**Invitation For Proposals**  
**Development of the West Kowloon Cultural District**

**Addendum No. 3**  
**(Issued on 30 March 2004)**

**PLAN 9A Land Status Plan of Scheme Area of West Kowloon Cultural District**

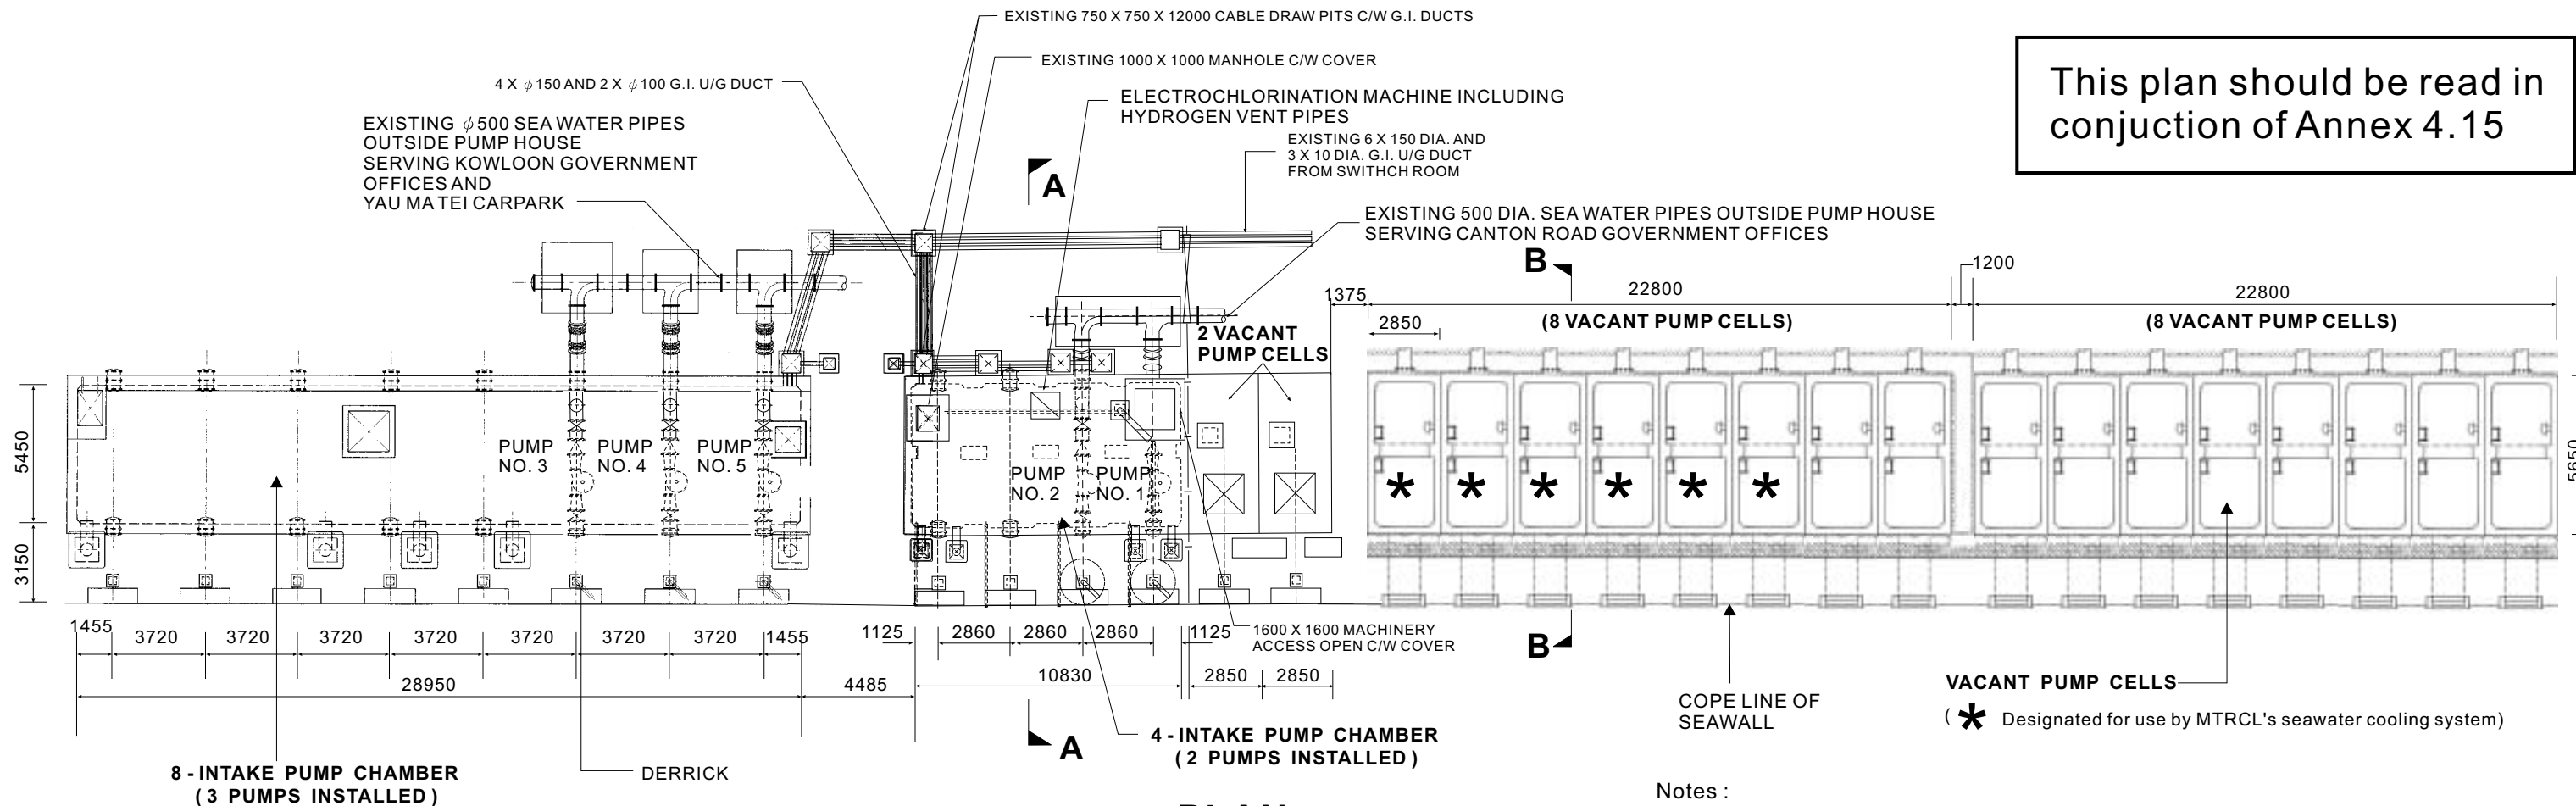
(d)	IFP (Hardcopy) IFP (CD-ROM) IFP (Website)	Plans 8, 9 and 12 of Volume Two	<p>(1) Replace <b>Plan 8</b> with <b>Plan 8A</b> at <u><b>Appendix C</b></u>.</p> <p>Replace all references of “<b>Plan 8</b>” in the IFP with “<b>Plan 8A</b>”. The layouts of MTRC sea water cooling system (development constraints nos. M4a to M4c in <b>Annex 4.11</b>) and temporary barging facilities for KSL (development constraints no. K3 in <b>Annex 4.11</b>) have been amended as shown on <b>Plan 8A</b>.</p> <p>(2) Replace <b>Plan 9</b> with <b>Plan 9A</b> at <u><b>Appendix C</b></u>.</p> <p>Replace all references of “<b>Plan 9</b>” in the IFP with “<b>Plan 9A</b>”. The layout of Site No. 4 for MTRC sea water cooling system (development constraints nos. M4a to</p>

Item	Documents Concerned	Reference in IFP	Amendments
			<p>M4c in <b>Annex 4.11</b>) has been amended as shown on <b>Plan 9A</b>.</p> <p>(3) Replace <b>Plan 12</b> with <b>Plan 12A</b> at <u><b>Appendix C</b></u>.</p> <p>Replace all references of “<b>Plan 12</b>” in the IFP with “<b>Plan 12A</b>”. The existing Government pump cells (development constraints no. G8 in <b>Annex 4.11</b>) designated for MTRC sea water cooling system (development constraints nos. M4a to M4c in <b>Annex 4.11</b>) have been amended as shown on <b>Plan 12A</b>.</p>

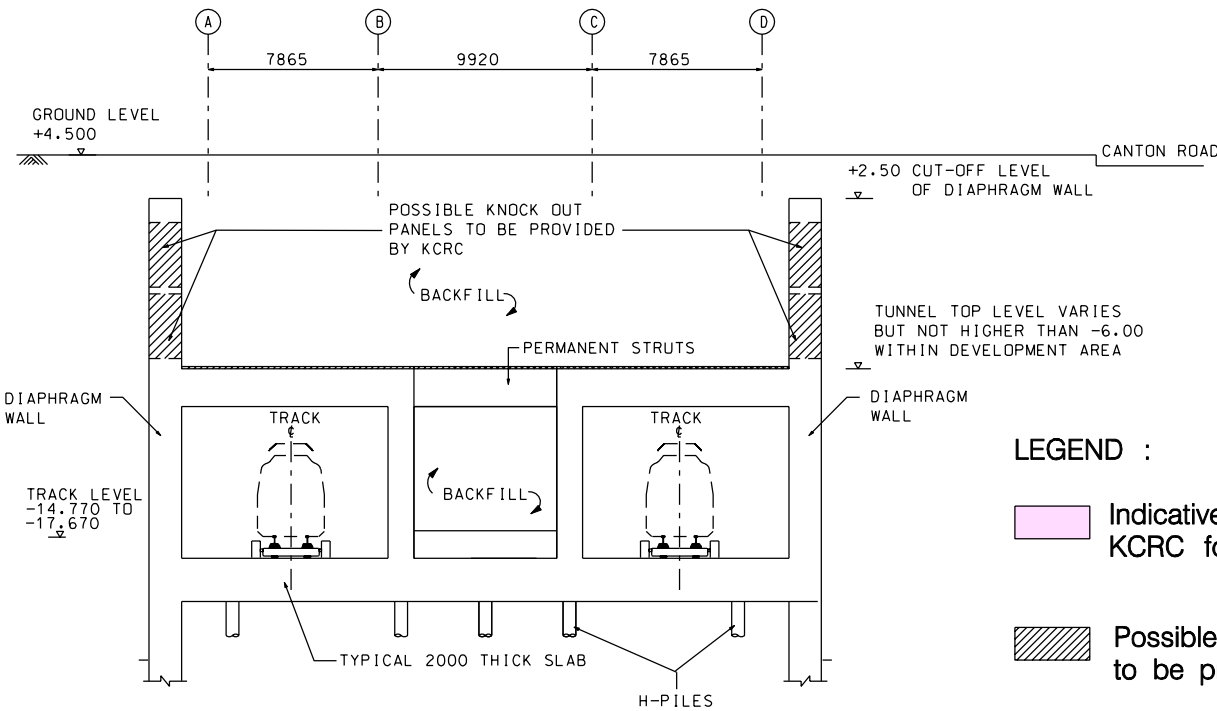
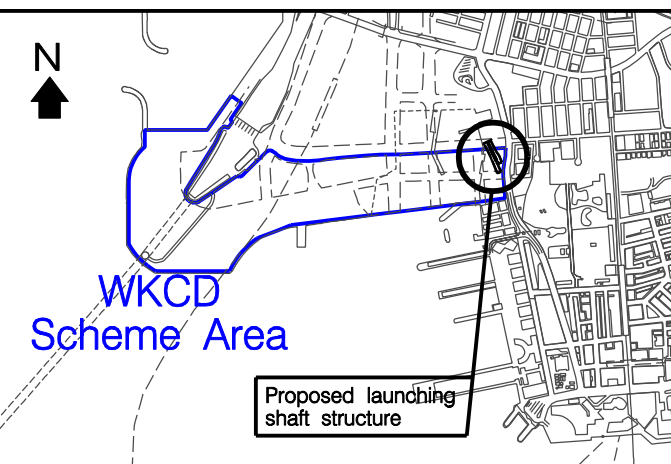
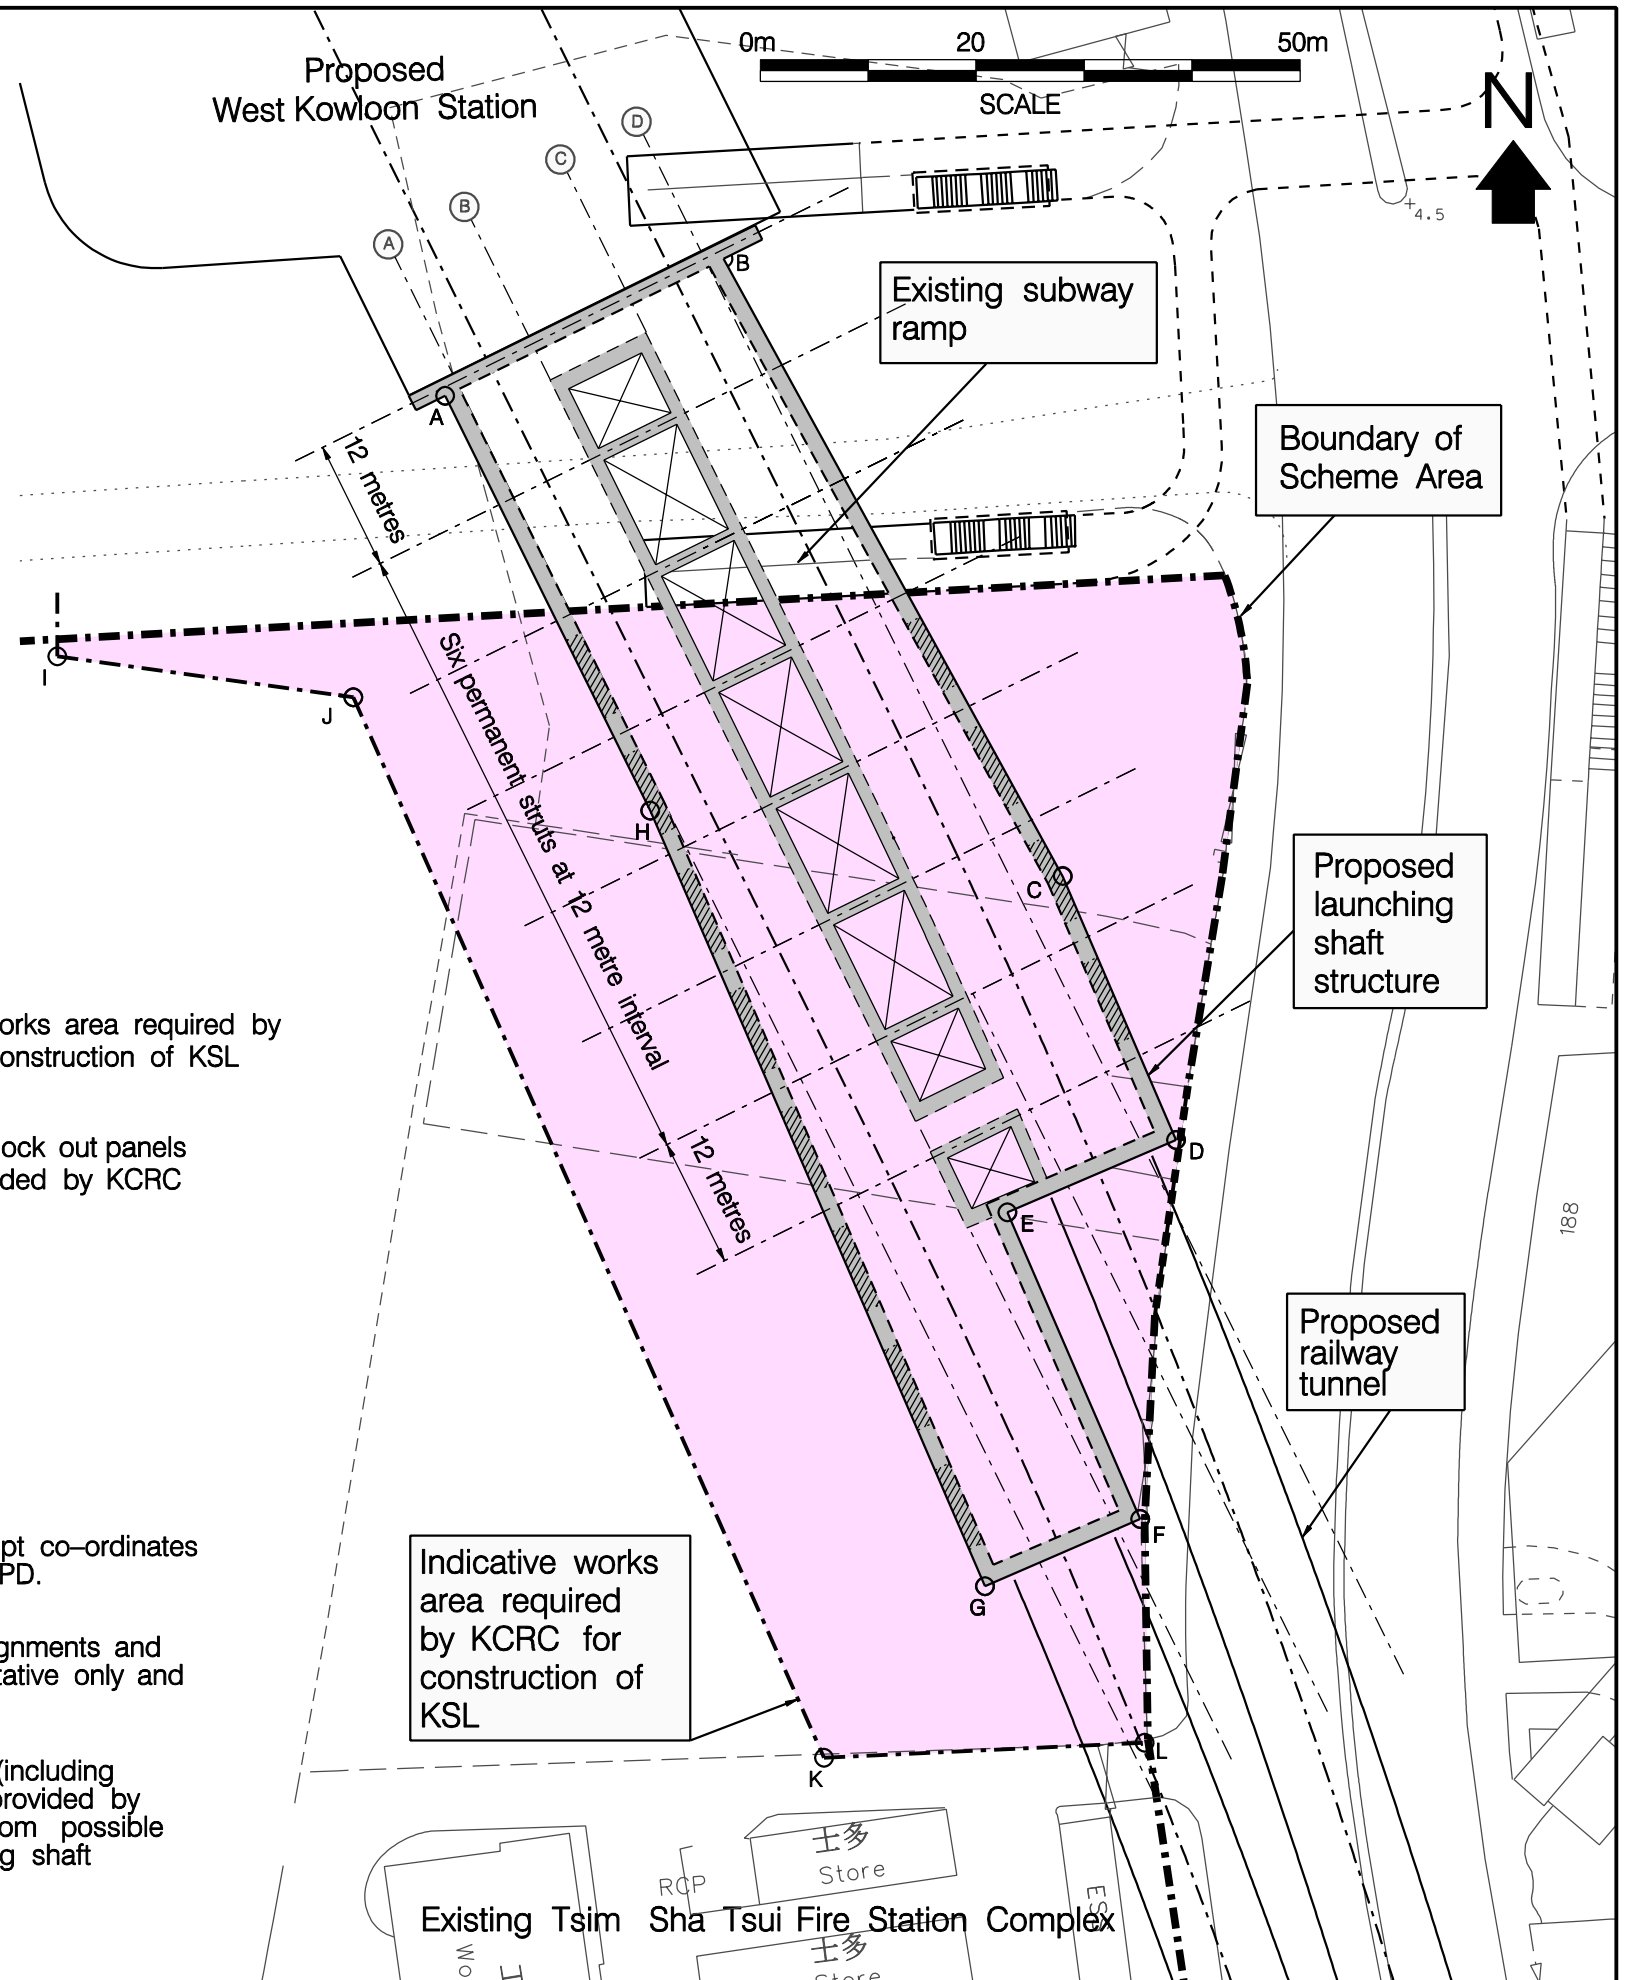
(d)	IFP (Hardcopy) IFP (CD-ROM) IFP (Website)	Plan of 14 of Volume Two	Add <b>Plan 14</b> West Kowloon Cultural District – Interface with KCRC Kowloon Southern Link at <b><u>Appendix C</u></b> .

3. An indicative works area within the Scheme Area as shown in **Plan 14** will be required by KCRC from early 2005 until the end of 2007 tentatively for the construction of railway tunnels and the launching shaft structure. Government is considering granting KCRC a short term tenancy in respect of the works area. The Successful Proponent may refer to the gazette plans of KSL for details. Possession of the works area may only be given to the Successful Proponent after expiry of the short term tenancy.

6. As at the date of the issue of this Addendum No. 3, KCRC is prepared to incorporate at its own cost structural enabling works up to the extent as shown in **Plan 14** in the launching shaft structure to support future building works of the Development, if any. Subject to paragraphs 4 and 5 above, part of the launching shaft structure, including the diaphragm walls, above the tunnel top levels of KSL as described in paragraph 1 above may be removed by the Successful Proponent at its own cost.
